**PENINSULA TOWNSHIP  
PLANNING COMMISSION  
AGENDA  
13235 Center Road  
Traverse City, MI 49686  
August 15, 2016  
7:00 p.m.**

Applicant:	The 81 Development Company, LLC
Applicant/Owner Address & Contact Information:	6978 Dixie Hwy, Suite A Clarkston, Michigan 48346 Ph. (248) 575-3300
Proposal Location:	Boursaw Road Section 29, Peninsula Township Parcel Id. #: 28-11-114-001-00 & 28-11-114-002-00
Zoning District:	R-1A, Rural & Hillside and R-1B, Coastal Zone Single and Two-Family Districts. Section 6.2.4 and 6.3.2 allows for Planned Unit Developments in the R-1A and R-1B zoning districts as a use permitted by Special Use Permit.
Comprehensive Plan:	The 2011 Future Land Use Map identifies the subject location as an area designated for rural agricultural usage. The objective of the rural agriculture use category is to preserve the important natural resources of the Township while allowing other limited uses which are deemed to be compatible with agricultural and open space uses.
Governing Ordinance:	Peninsula Township Subdivision Control Ordinance No. 8 and the Peninsula Township Zoning Ordinance

## 2. Site Plan Evaluation-

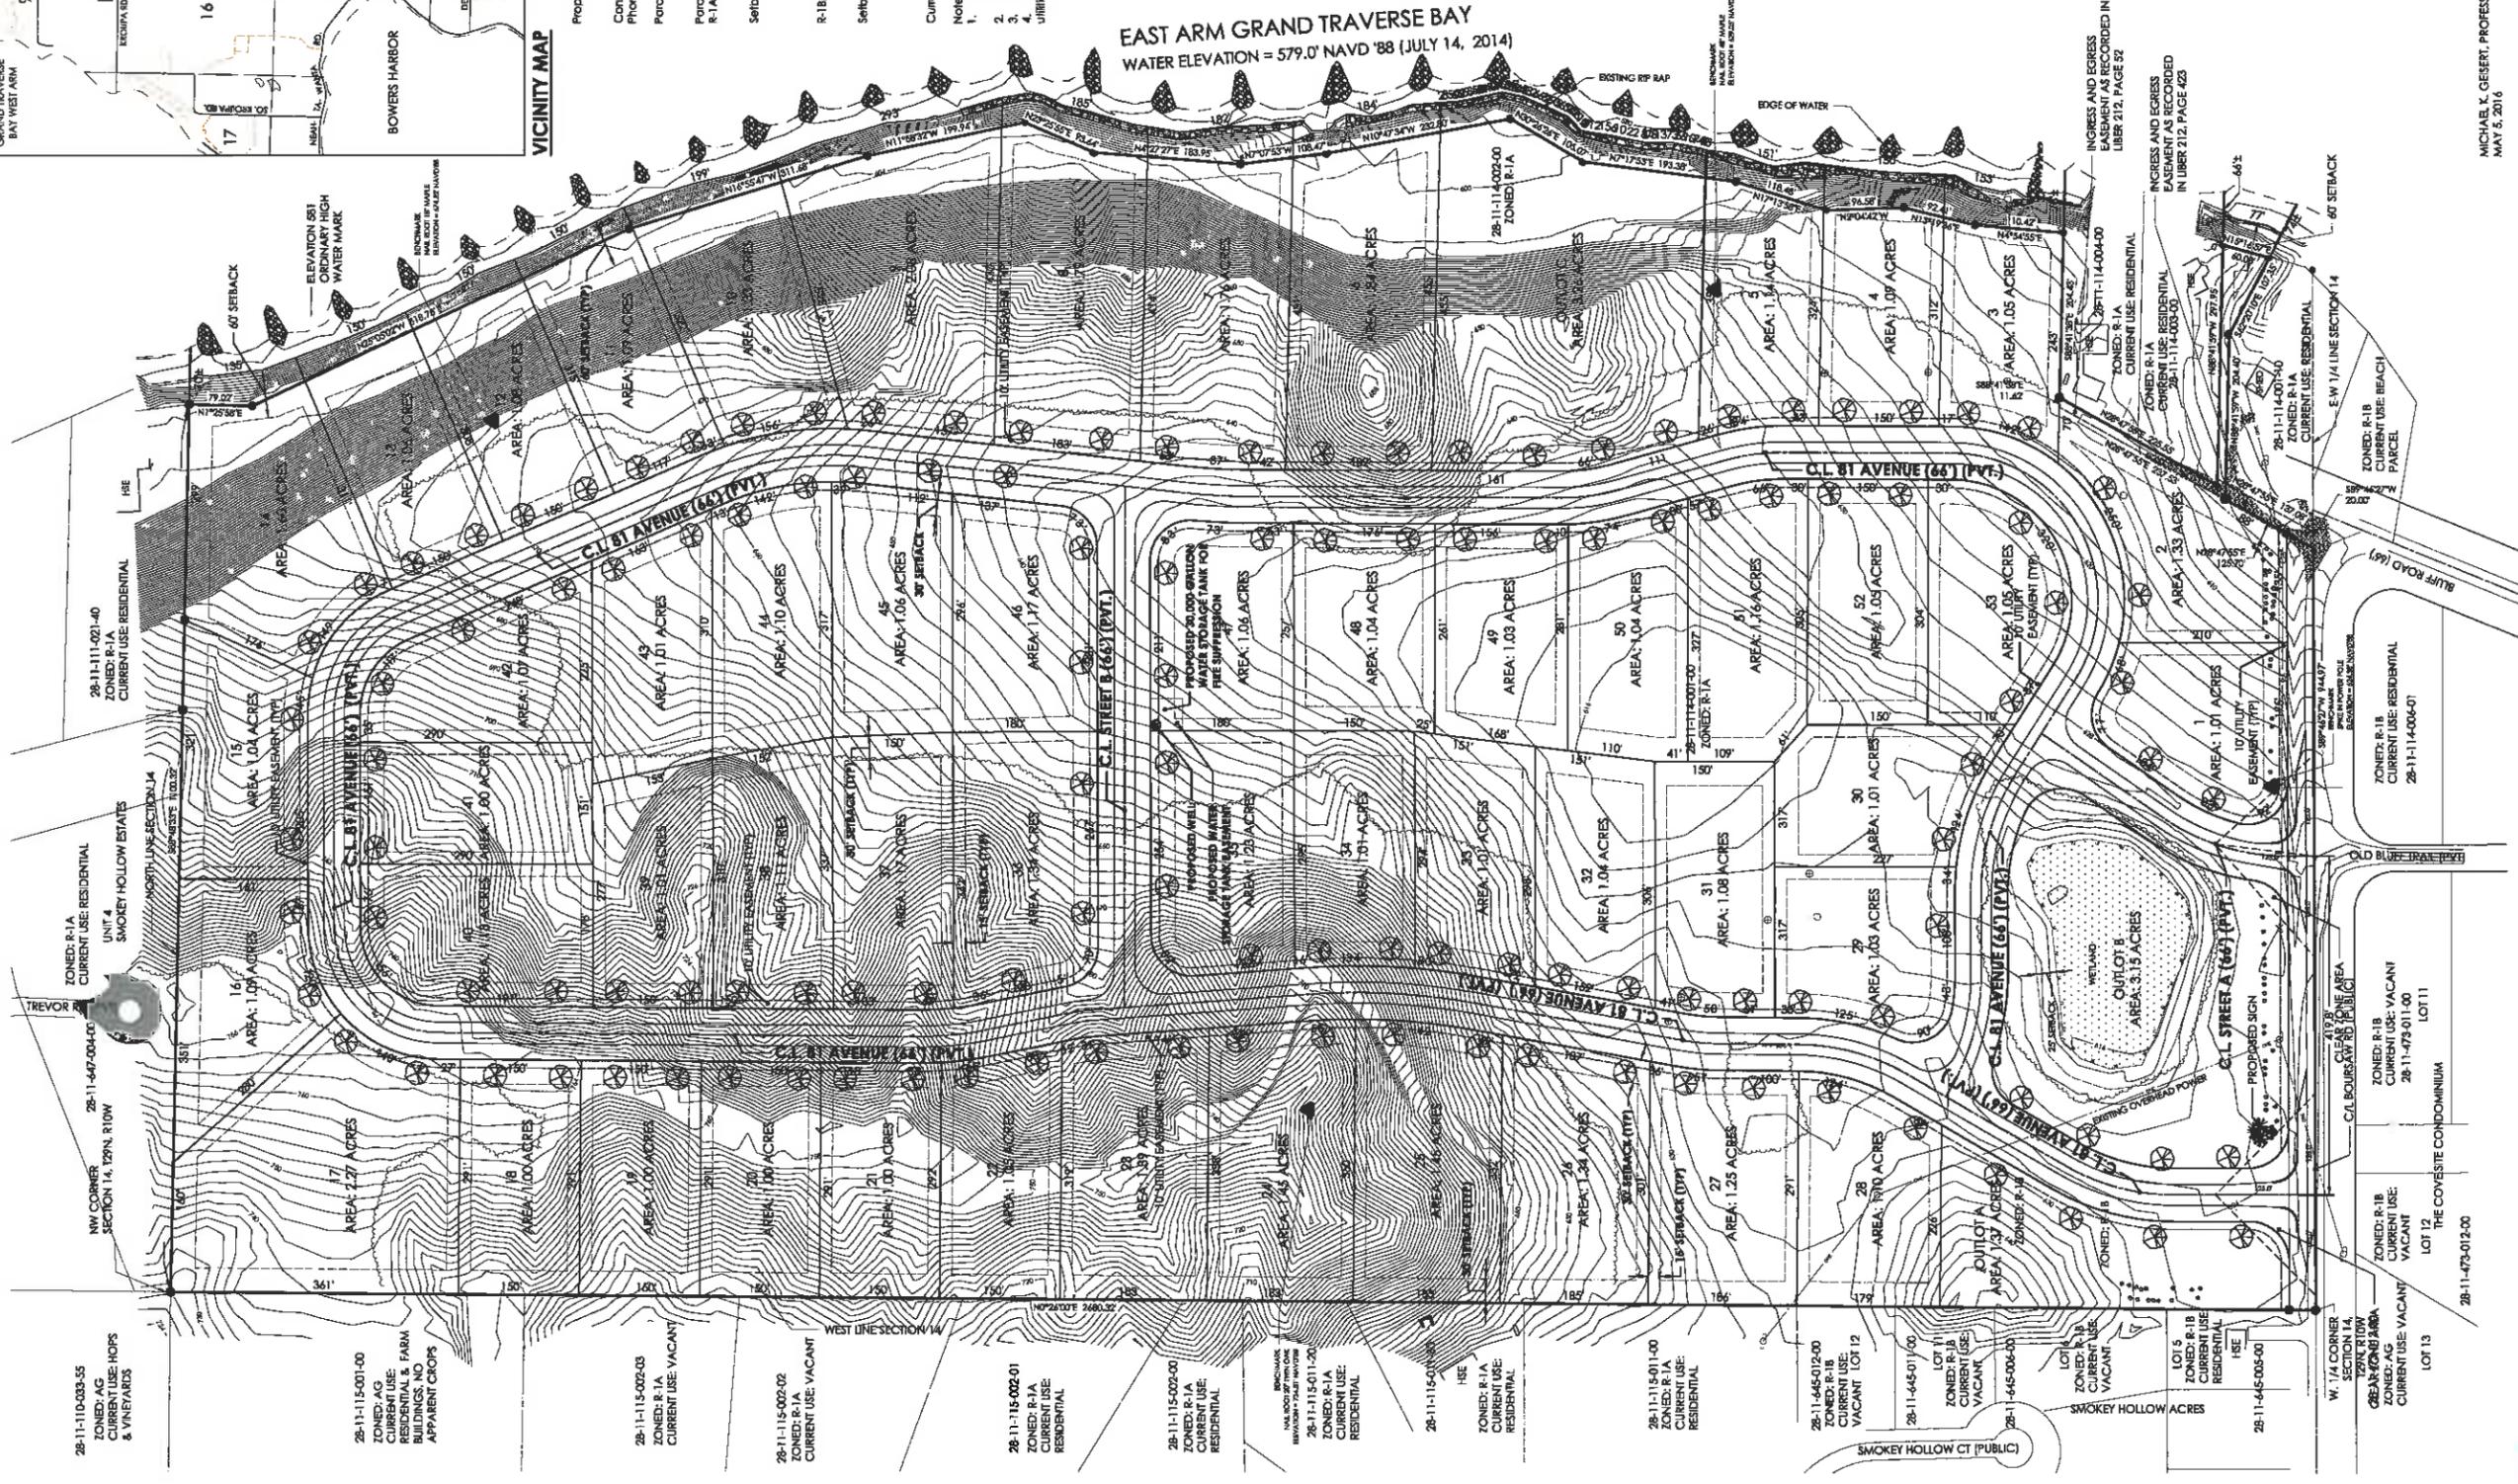
- 2.1 Layout-** The applicant's is proposing a fifty-three (53) unit plat subdivision to be accessed by a private road. Thirteen (13) units will have private waterfront access and will be located along the eastern boundary of the property. The remaining forty (40) units do not have water access.

- 2.2 Lot Analysis-** The average lot size is approximately 1 acre with a minimum of 150 feet of frontage on the private road. All fifty-three (53) of the proposed lots meet the 2.5 to 1 lot depth to width ratio. The proposed plat includes the required ten (10) foot utility easement in the lot area calculations. This easement is required to be part of the road design and shall be excluded from the lot area calculations. **The applicant shall resubmit the plat with the appropriate lot calculations to ensure compliance with the minimum lot area as required by Section 6.8 of the Peninsula Township Zoning Ordinance.**

Lots 1 & 2 are defined as back-up lots. Section 4.7.5 of the Subdivision Control Ordinance requires a landscaped easement along the rear at least twenty (20) feet wide to restrict access to arterial streets, to minimize noise, and to protect outdoor living areas. **This required element shall be shown on the plat.**

Lot 17 shall be subject to a 100 foot setback for all structures as the lot is adjacent to agricultural land as required by section 7.77.1.1 (1) of the Peninsula Township Ordinance. **This required element shall be shown on the plat.**

Lots 1, 29, 35, 36, 40, 42, 46, 47, & 53 are corner lots. Section 4.7.4 of the Subdivision Control Ordinance requires corner lots to have “extra width to permit appropriate building setback from both streets or orientation to both streets.” **The plat shall be resubmitted showing the required front and rear setback lines on the corner lots should the principal structure align to either street to demonstrate appropriate building envelopes are available.**

**2.3 Vehicular Circulation-** There are two ingress/egress points along Boursaw Road; one at the intersection of Boursaw and Old Bluff Trail and another approximately 420 feet to the west. The private road will loop through the site and provide connectivity by two east-west connector streets. **The proposed private road right of way does not encompass the 10 foot utility easement as required by section 4.1.3 of the Peninsula Township Subdivision Control Ordinance No. 8.**

Section 4.1.2 (5) requires streets to be arranged in relation to topography “so as to result in usable lots, safe streets, and reasonable gradients.” The plat design shows lots that have significant grade change (i.e. lot 39 has a 17% grade) and portions of the proposed private road traverse a 16% grade. The Peninsula Township Zoning Ordinance prohibits private roads that exceed 12% grade. **The applicant will need to submit engineering to show the grading plan along with impacts on soil erosion and storm water to ensure the design is in compliance with the Township ordinances.**

Section 4.3 of the Subdivision Control Ordinance requires the developer to submit plans showing the probable location of the driveways to each lot in areas having steep topography generally in excess of 10% gradient. **This element will need to be included on the plat as required by the ordinance.**

**2.7 Environmental Issues-** Section 4.9.2 of the Subdivision Control Ordinance requires that natural features which add value to the residential development and enhance the attractiveness of the community shall be preserved. There is significant tree cover, 2,000+ lineal feet of East Bay shoreline, and natural bluffs and ridgelines present on the site. The applicant has not identified the valuable natural features on site or presented a plan for preservation of these features in the environmental report. **The applicant shall include the plans for preservation of the valuable natural features on site as part of the plat.**

Notes on the plan indicate outlots may be used for "waterfront access". **The shared waterfront access is regulated by Section 7.4.2 and the plat documents shall reflect compliance with this section of the Ordinance.**

1. The plat shall be revised to reflect the required road structure (including the 10 foot utility easement) as required by section 4.1.3 of the Subdivision Control Ordinance.

2. The plat shall be revised to show the correct lot calculations after removing the 10 foot utility easement to ensure compliance with the minimum lot area as required by Section 6.8 of the Peninsula Township Zoning Ordinance.

3. The plat shall be revised to show the required landscape easement on lots 1 & 2 as required by section 4.7.5 of the Subdivision Control Ordinance.
4. The plat shall be revised to show the required buffer on lot 17 as required by section 7.7.1.1 (1) of the Peninsula Township Zoning Ordinance.

5. The plat shall be revised to show the required front and rear setback lines on lots 1, 29, 35, 36, 40, 42, 46, 47, & 53 should the principal structure align to either street to demonstrate appropriate building envelopes are available.

6. The plat shall be revised to show the probable location of the driveways to each lot. The grading and structures for driveways shall be shown on plans required under section 5.2 of the Subdivision Control Ordinance.

7. The applicant shall submit engineering to show the grading plans along with impacts on soil erosion and storm water to ensure the design is in compliance with the Township ordinances.

8. The Planning Commission should petition the Township Board to determine the acceptability of the streets as private as part of their deliberations on the plat.

9. The applicant shall revise the environmental report to include the identification of valuable natural features and plans to preserve these features as required in section 4.9.2 of the Subdivision Control Ordinance.
